PRCOM20224906

REVISDE 6/22/2023

I-470 BUSINESS & TECHNOLOGY CENTER, LOT 7

ISSUED FOR PERMIT OWNER REVISIONS

SHEET NO.
C402

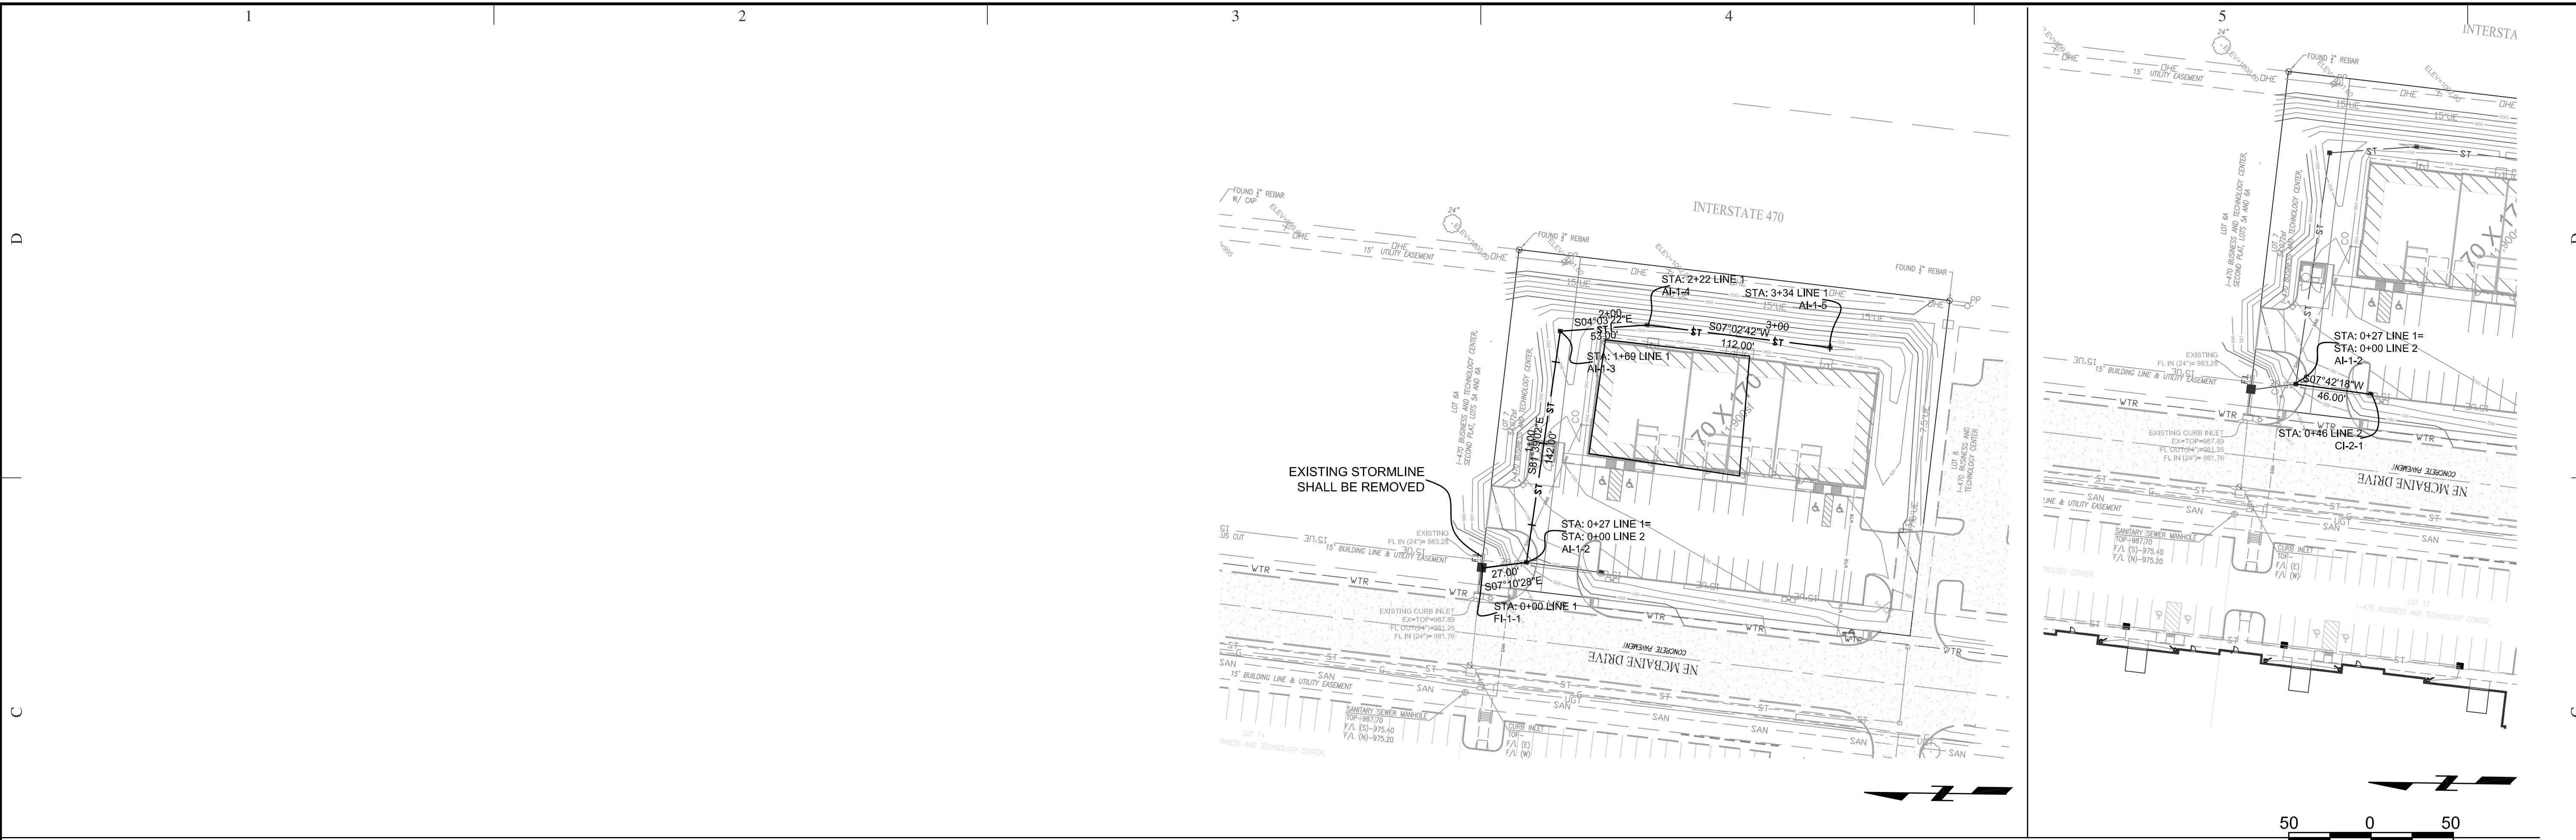
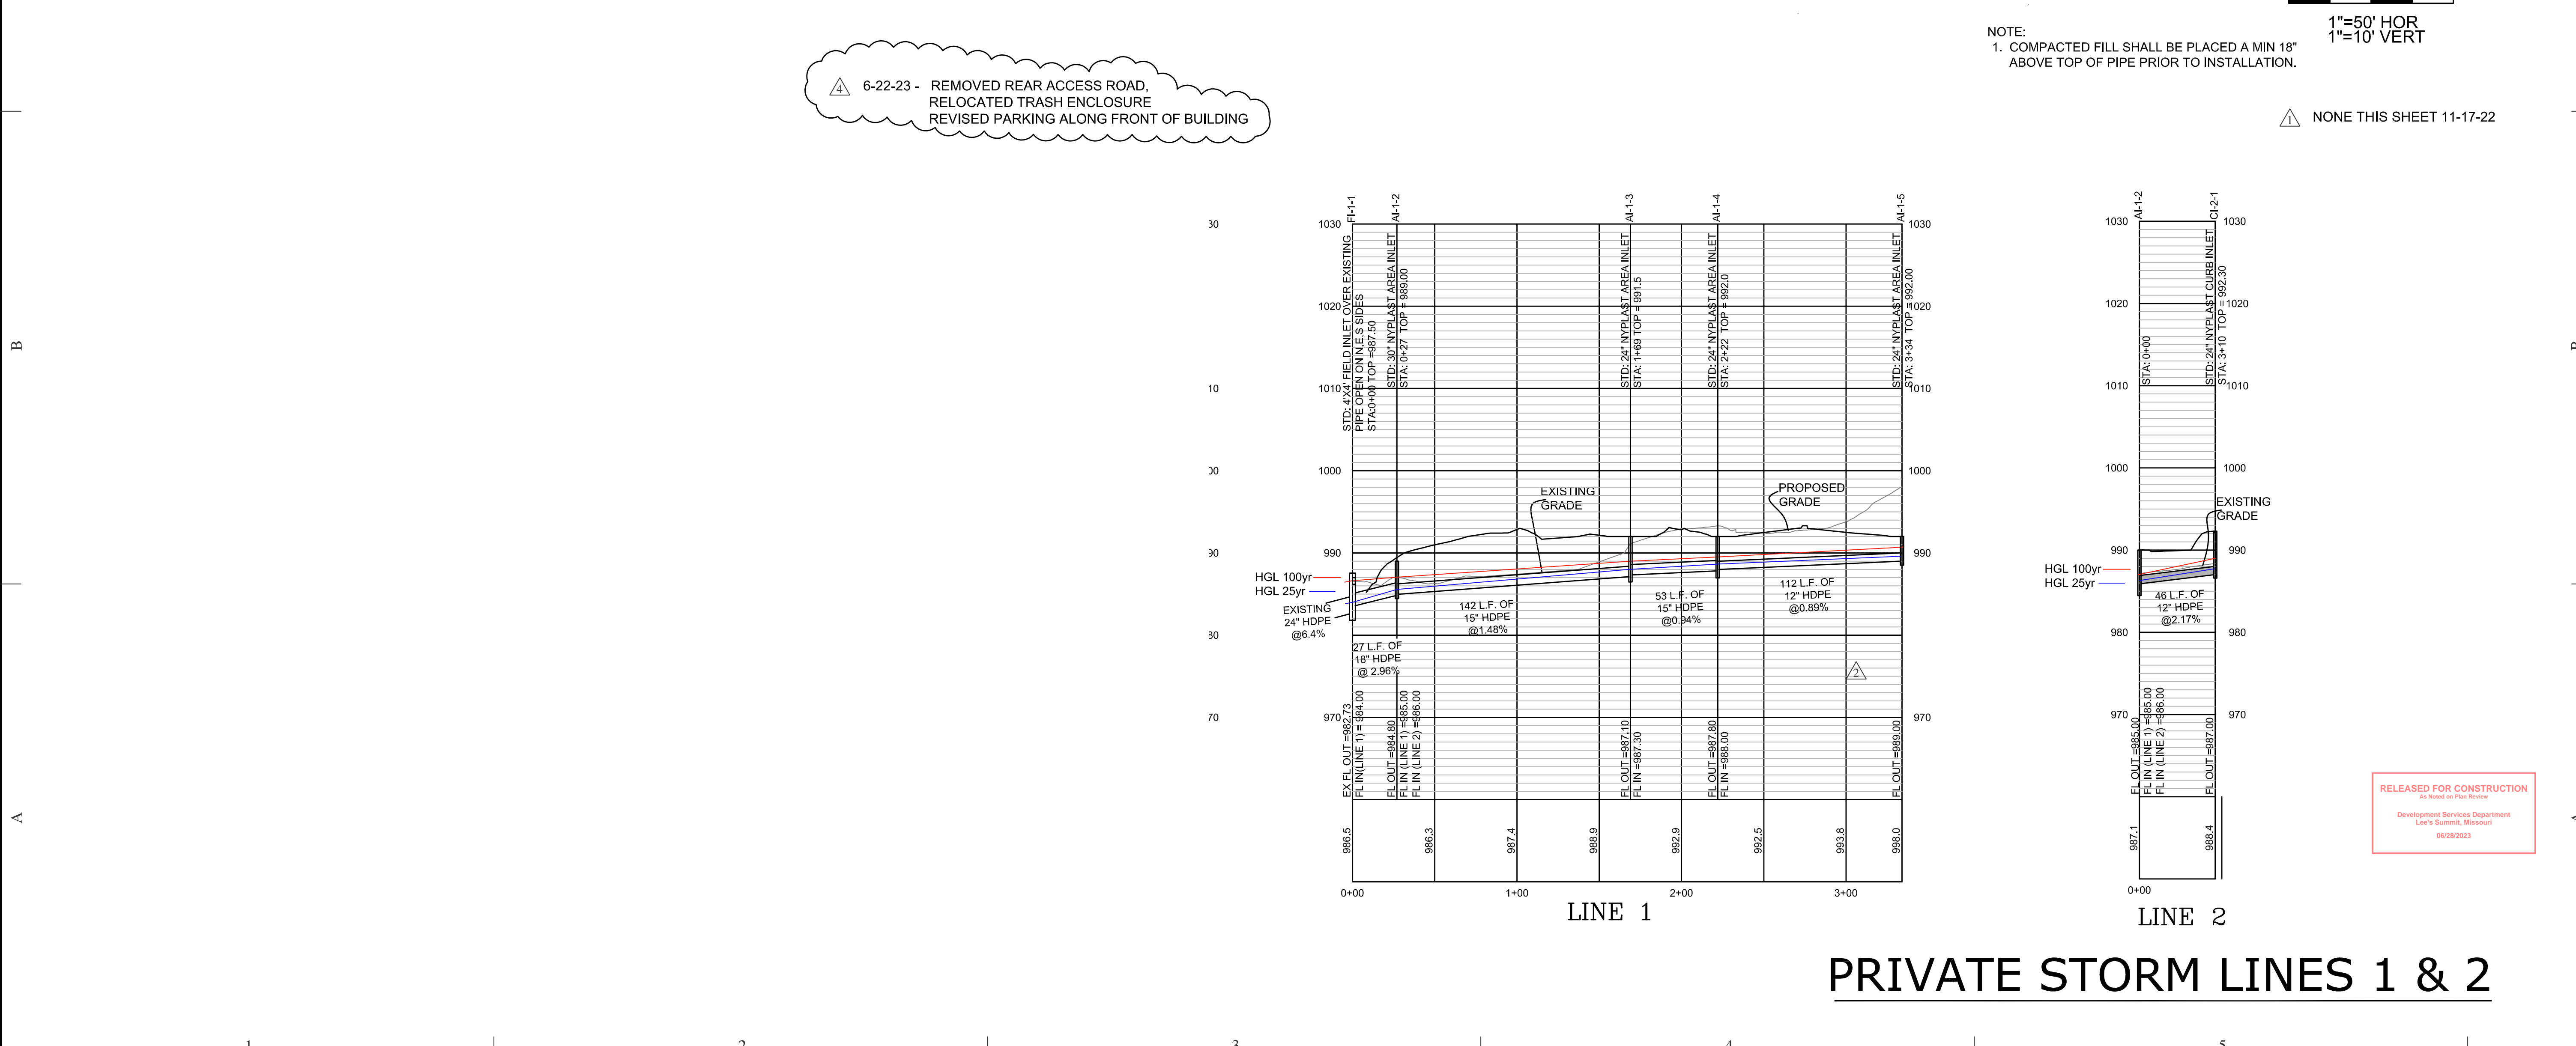
△ 6-22-23 - REMOVED REAR ACCESS ROAD, RELOCATED TRASH ENCLOSURE, REVISED PARKING ALONG FRONT OF BUILDING
